Date: May 28, 2024
Attention: Kimberly Thompson, Natural Resource Specialist, FrontCounter BC
Re: Crown Land Tenure Application (Tracking Number 100439391)
 Land / Foreshore Use Application: Shoreline Erosion Mitigation ("Green Shoring")
 Information Request IR-001

10 **INFORMATION REQUEST RESPONSES**

PROJECT TITLE:
BEACH EROSION PROJECT
2022.68 QUARRY DRIVE

Figure 1: Photo 1 of existing natural deposits of "rock clusters" at the Project Site.

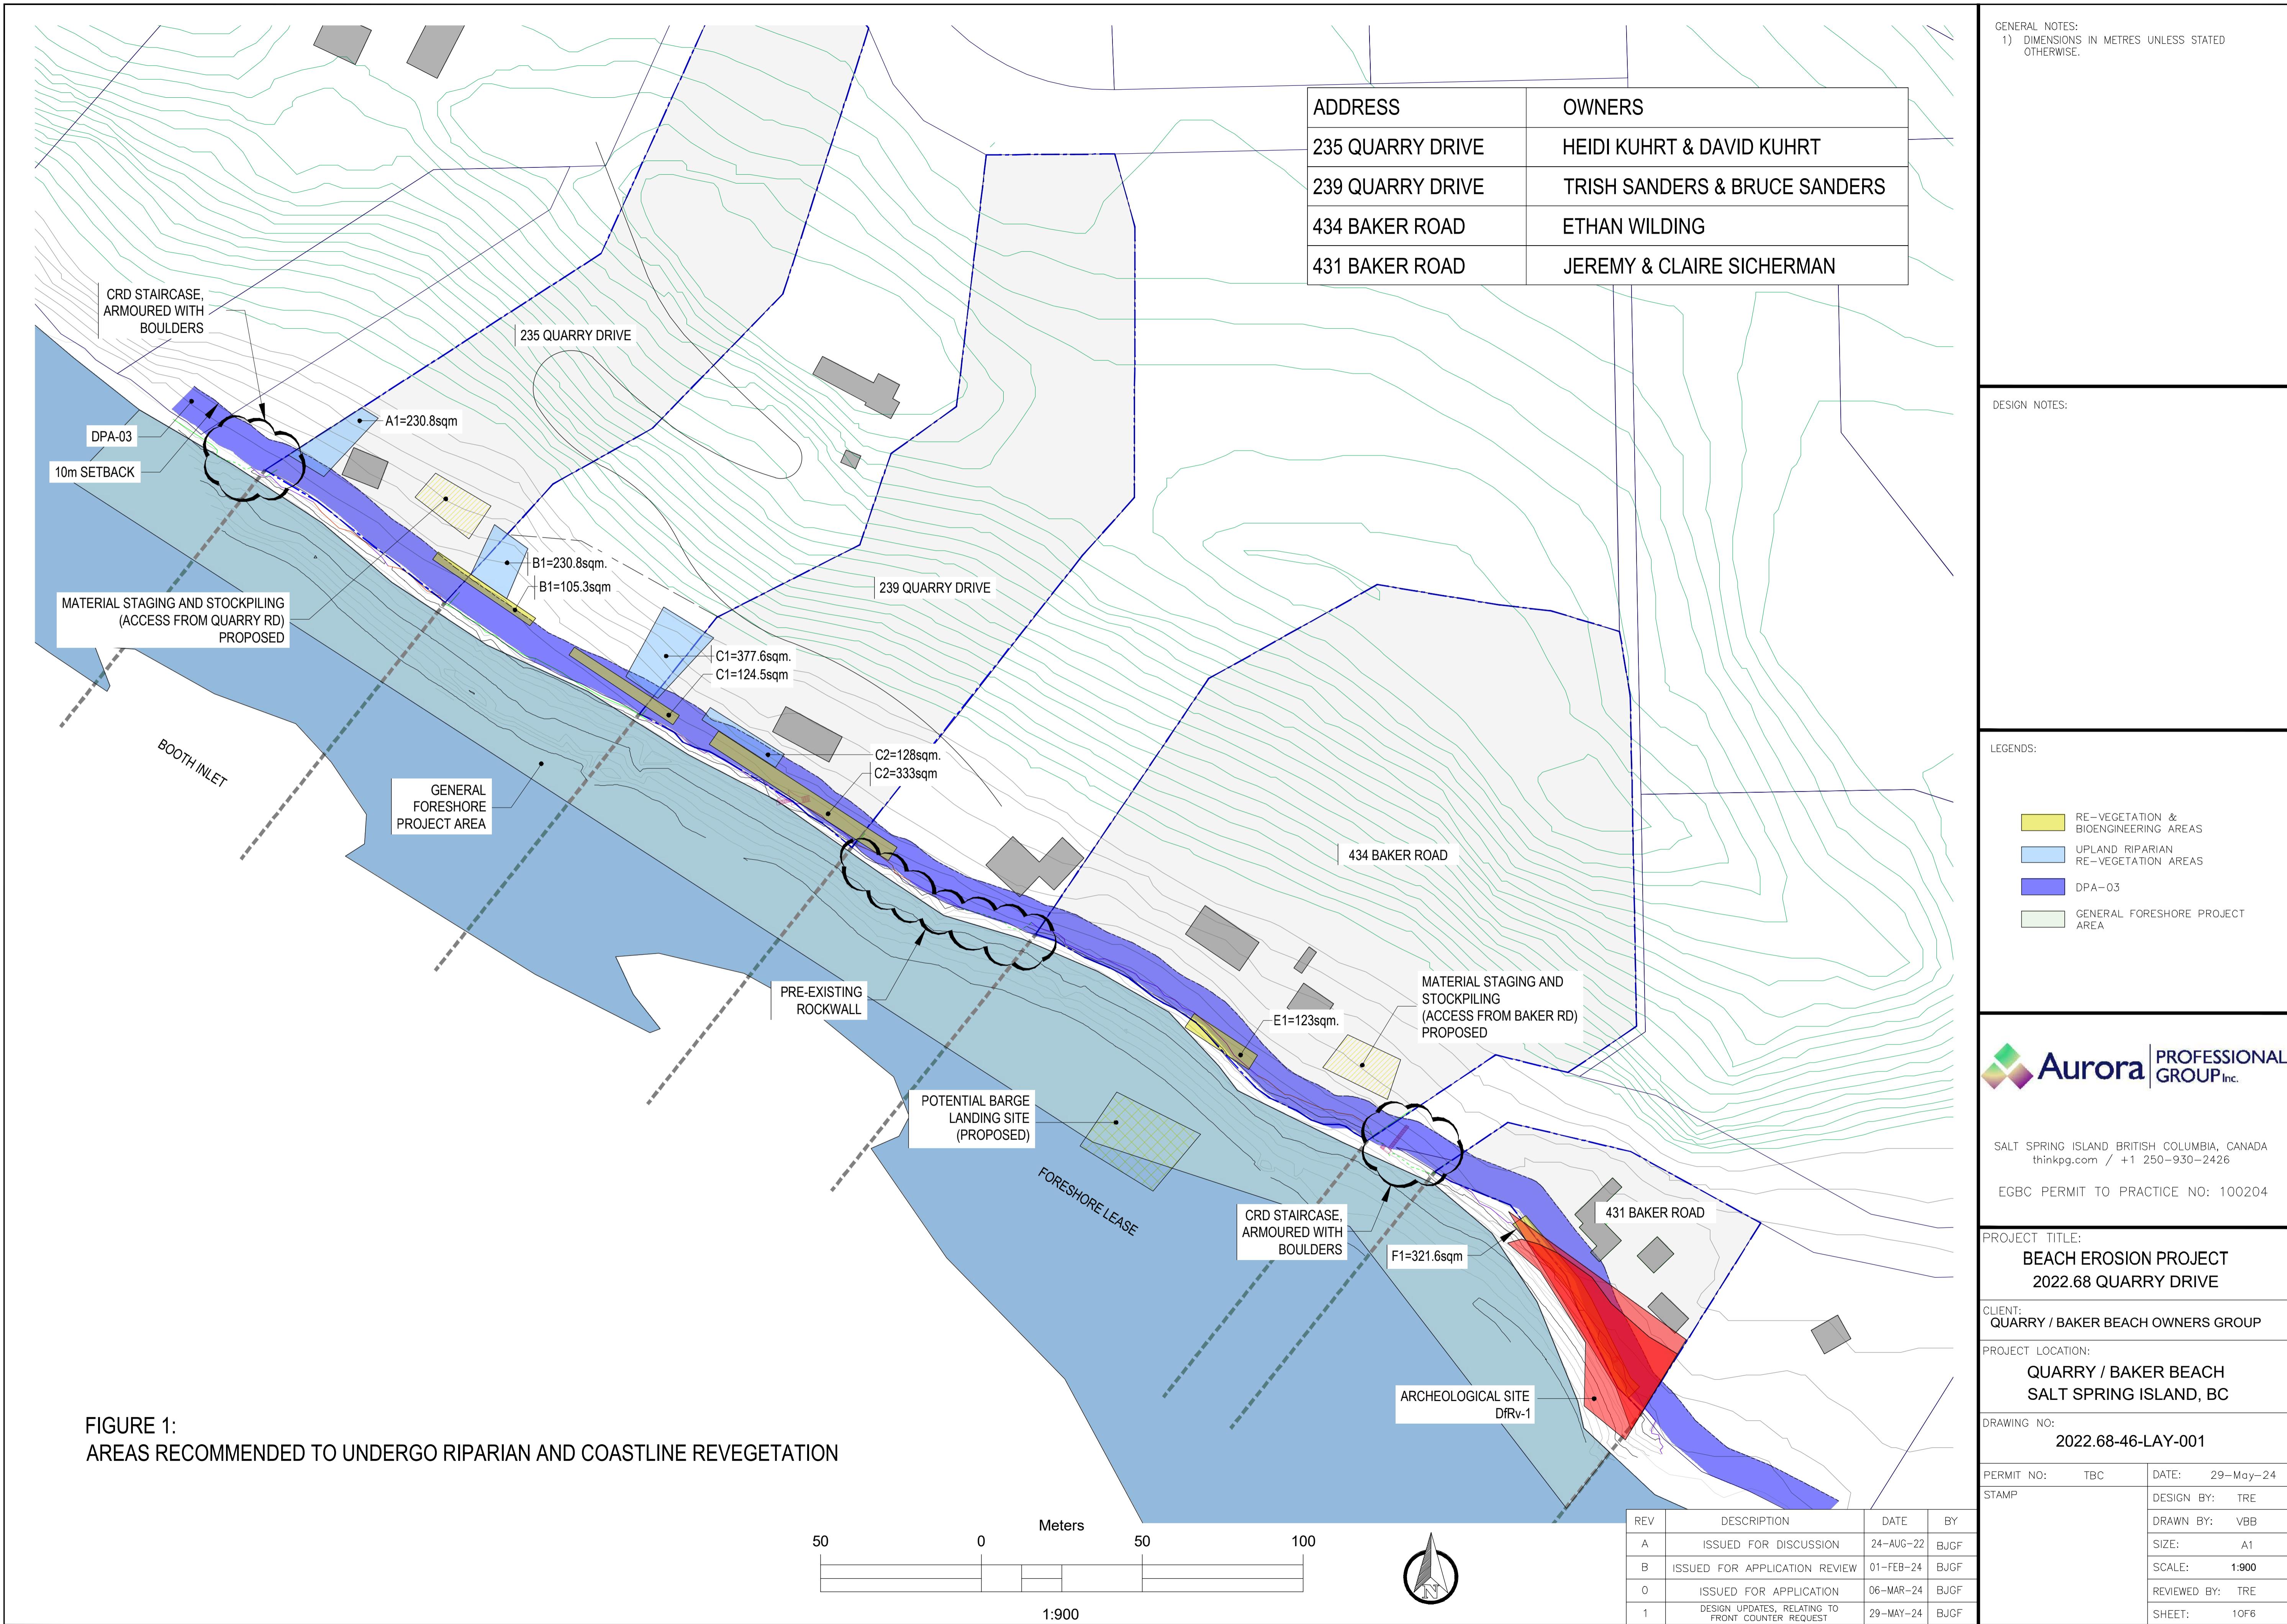
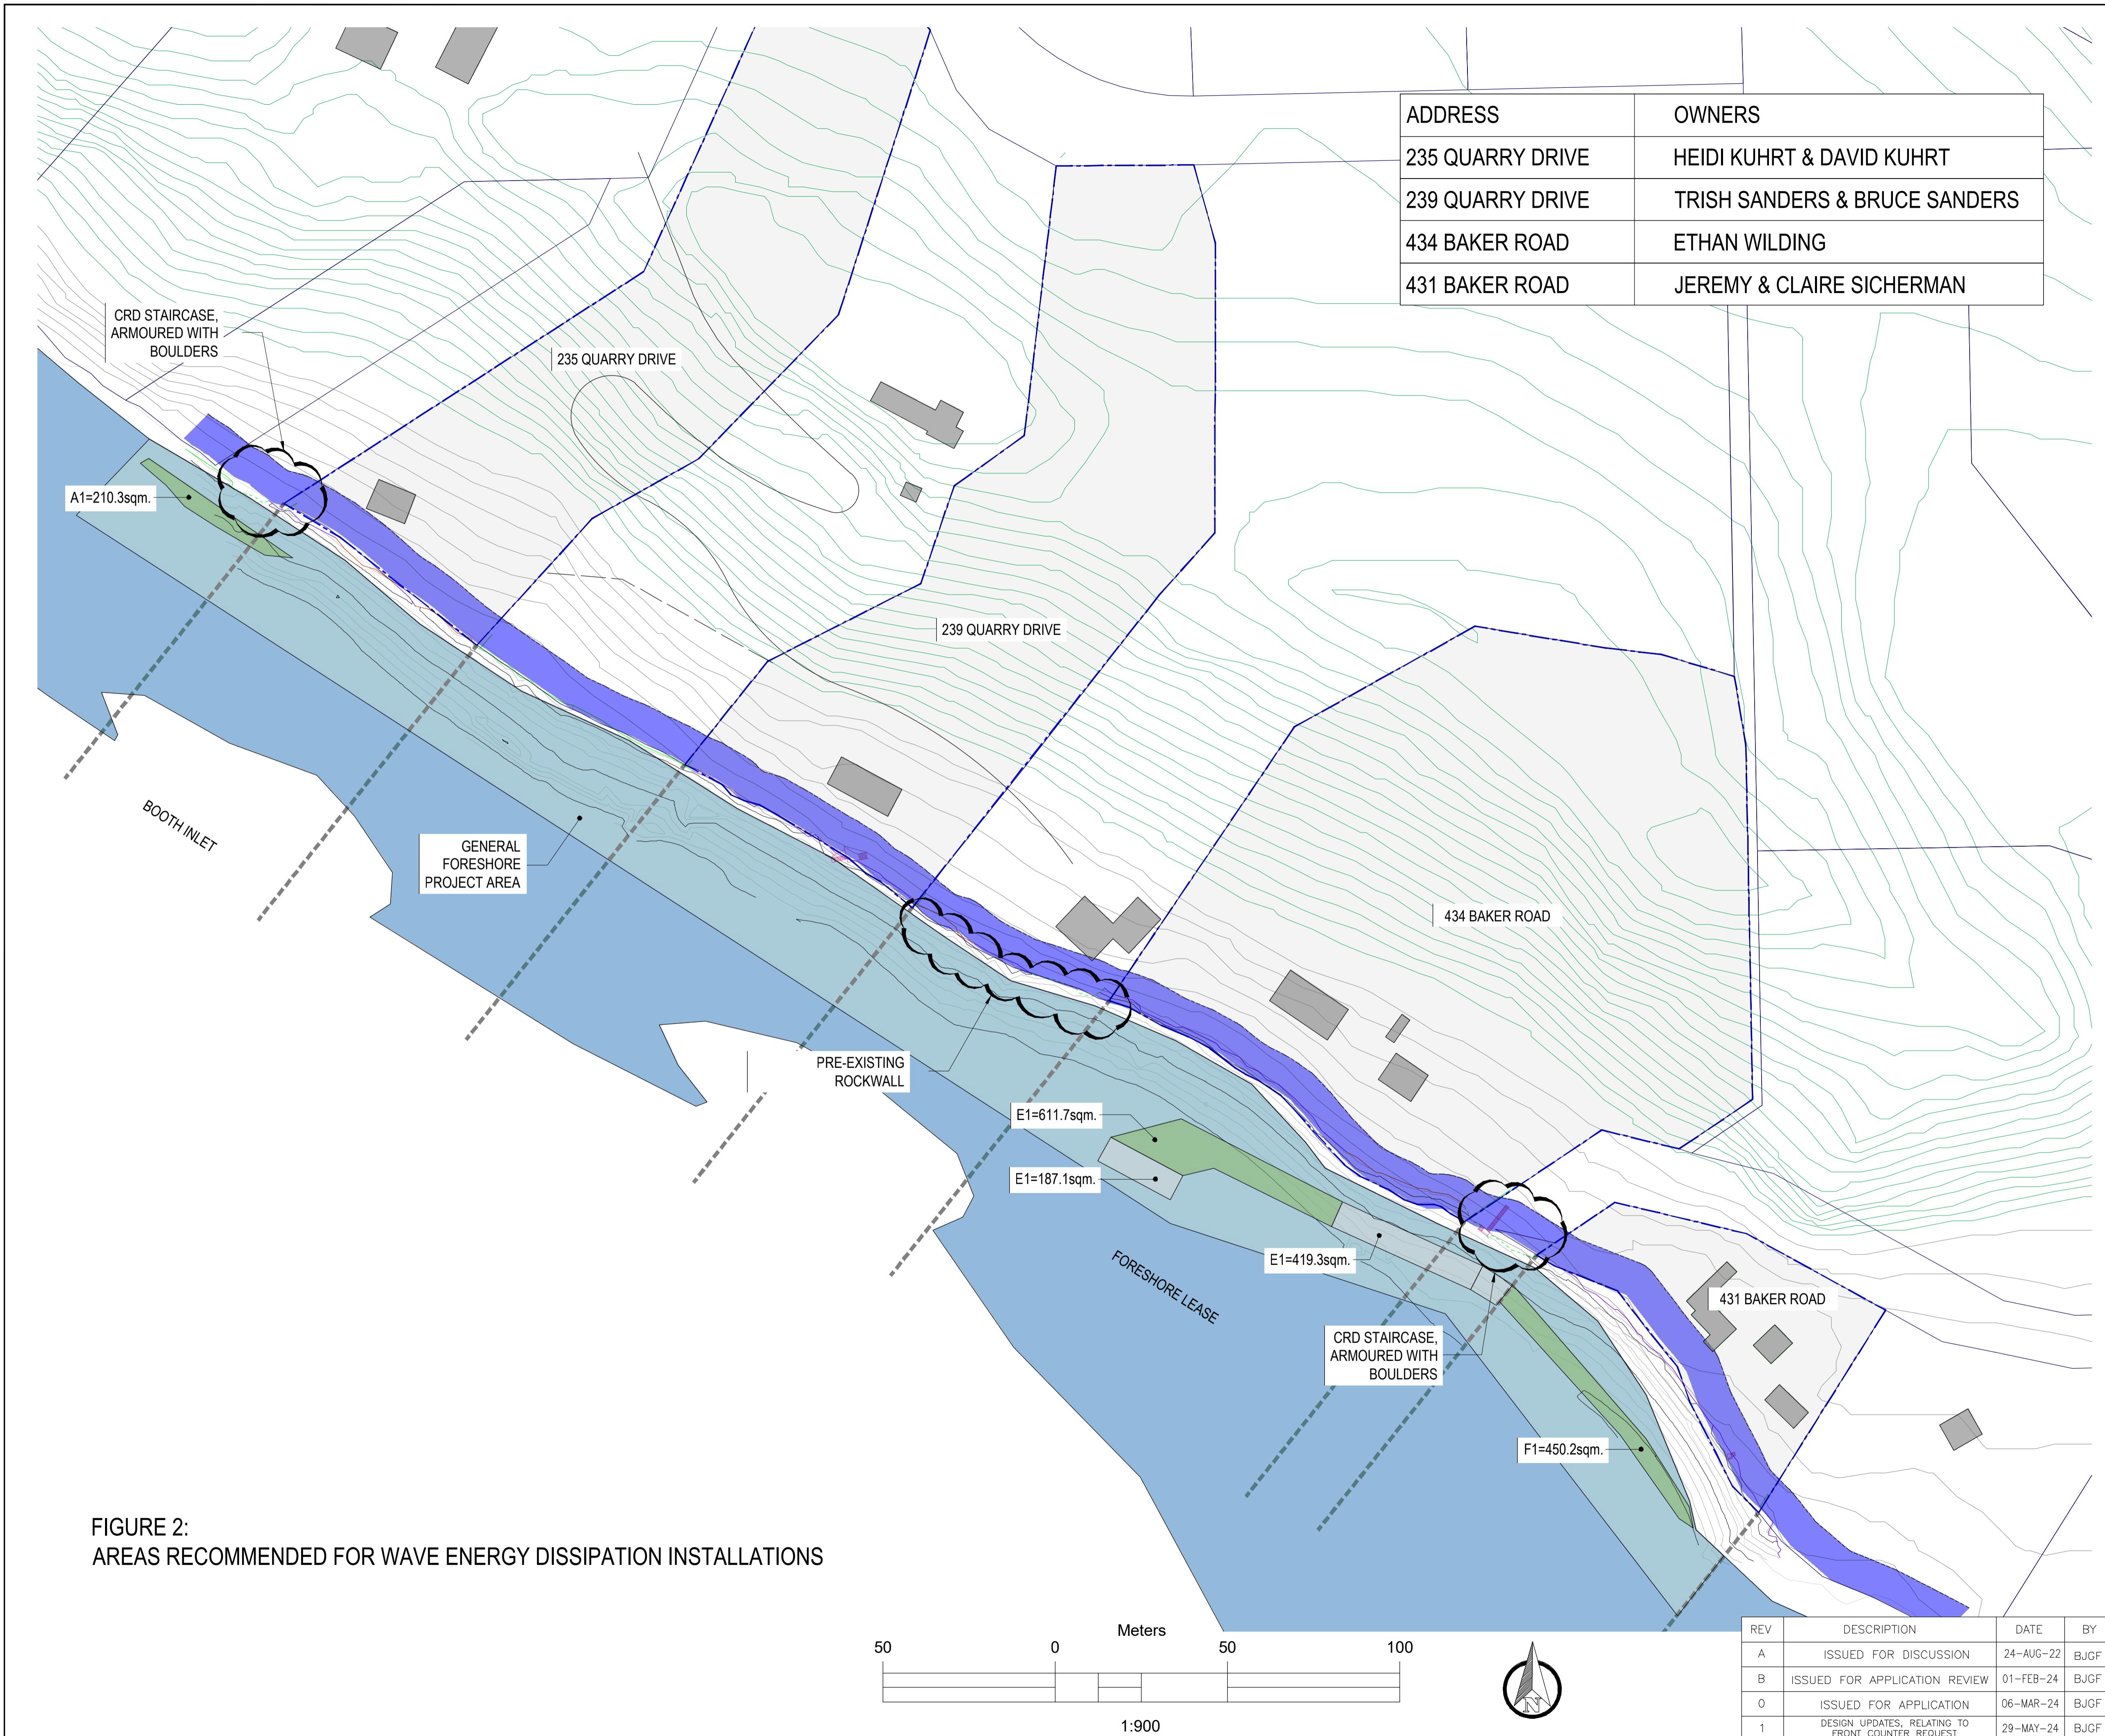
29 04. *Section 3.2 of TRE's "Assessment of Marine Shoreline Characteristics" report recommends sparse
 30 placement of boulders in the indicated areas to deflect waves. However, the side view plan in the
 31 drawing package shows non-uniform rock clusters. Please update the application package to
 32 provide more information about the boulders or rock clusters such as the size range of the rocks,
 33 approximate size of each cluster, approximate number of clusters and approximate spacing
 34 between clusters.*

- 35
- Response IR-001.04.1 (GEO, TRE): More specifically, "placement of boulders" or "non-uniform rock clusters" can be described as 'boulder placement for wave-energy dissipation'. These are rock clusters that mimic existing natural deposits in the area. See attached for field photos for examples of existing natural deposits at the Project.
- 36
- 37
- 38

- 43 • Response IR-001.04.2 (GEO, TRE): Cluster Specification
- 44 i. 0.5 – 1.2m boulders, sandstone or low sulphide granite, rounded to sub-rounded
45 (no blast rock)
- 46 ii. Amoebic clusters of 10 – 15, generally with 20% density within the areas
47 designated on the plans.
- 48 iii. Spaced 0.5 – 1.0m
- 49 iv. -Placed on the largest side to minimize topple/movement
- 50 • Response IR-001.04.3 (ENG): Drawings have been updated to include further "wave
51 energy dissipation installations" terminology.
